# Access Compliance Report

## Public Rights-of-Way

### (Curb Ramps)

Intersection ID: 10023986	Main Street: COPPER_WY	Cross Street: N/A	Location: NE
ADA ID: BC845B6B3EAD	Ramp Type: BlendTrans1	Initial Pass/Fail: Fail	Overall Compliance: No
		Severity Score: 8.75

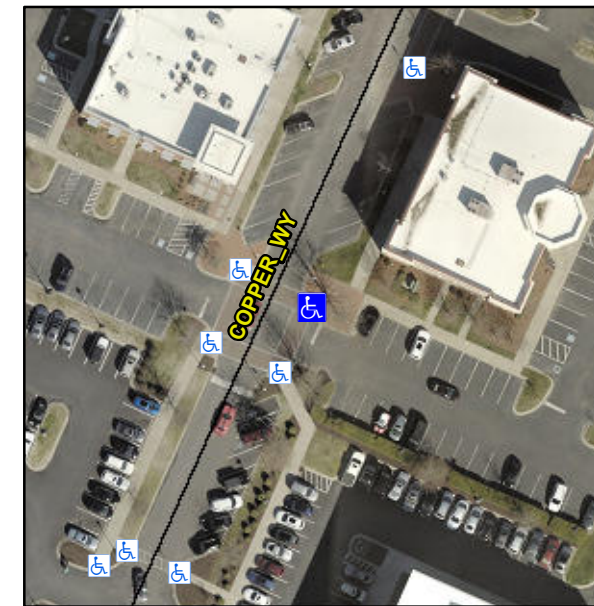
**Not Found, R304.5.1**

Compliance	Description	Data	Compliance	Description	Data
N/A	Ramp Length (in)	58.5	Yes	BlendTrans Slope (%)	2.8
No	Ramp Width (in)	46.0	Yes	BlendTrans XSlope (%)	0.3
N/A	Flare Type LT	N/A	N/A	Flare Type RT	N/A
N/A	Flare Slope LT (%)	N/A	N/A	Flare Slope RT (%)	N/A
N/A	Flare Traversable LT?	N/A	N/A	Flare Traversable RT?	N/A
N/A	Landing Length (in)	N/A	N/A	DWS Provided?	N/A
N/A	Landing Width (in)	N/A	N/A	DWS Contrast?	N/A
N/A	Landing Slope (%)	N/A	N/A	DWS Length (in)	N/A
N/A	Landing X Slope (%)	N/A	N/A	DWS Full Width?	N/A
N/A	Landing Curb? (Y/N)	N/A	N/A	DWS Offset (in)	N/A
N/A	Shared Landing?	N/A			
N/A	Gutter Ponding?	N/A	N/A	Gutter Slope (%)	N/A
N/A	Gutter Lip Ht (in)	N/A	N/A	Gutter X Slope (%)	N/A
N/A	Painted X Walk1?	Yes	N/A	Painted X Walk2?	Yes
	X Walk 1 Direction	To NW		X Walk 2 Direction	To SW
	X Walk 1 Width (in)	101.0		X Walk 2 Width (in)	109.0
	X Walk 1 Slope (%)	1.8		X Walk 2 Slope (%)	1.3
	X Walk 1 X Slope (%)	2.7		X Walk 2 X Slope (%)	0.3

N/A	Ramp inside XWalk1?	Yes	N/A	Ramp inside XWalk2?	Yes
	Road Slope (%)	0.3		Clear Space?	N/A
	Road X Slope (%)	2.0	N/A	Clear Space to XWalk (in)	N/A
N/A	Any Obstructions?	N/A	N/A	Storm Grate/Utility Hazard?	N/A
	Obstruction Type			Storm Grate/Utility Type	
		N/A			N/A
			Yes	Surface Condition? (G/P)	Good
			No	Curb Slope (%)	18.2

**Remove & Replace Curb Ramp With Two New Directional Ramps or Equivalent.**
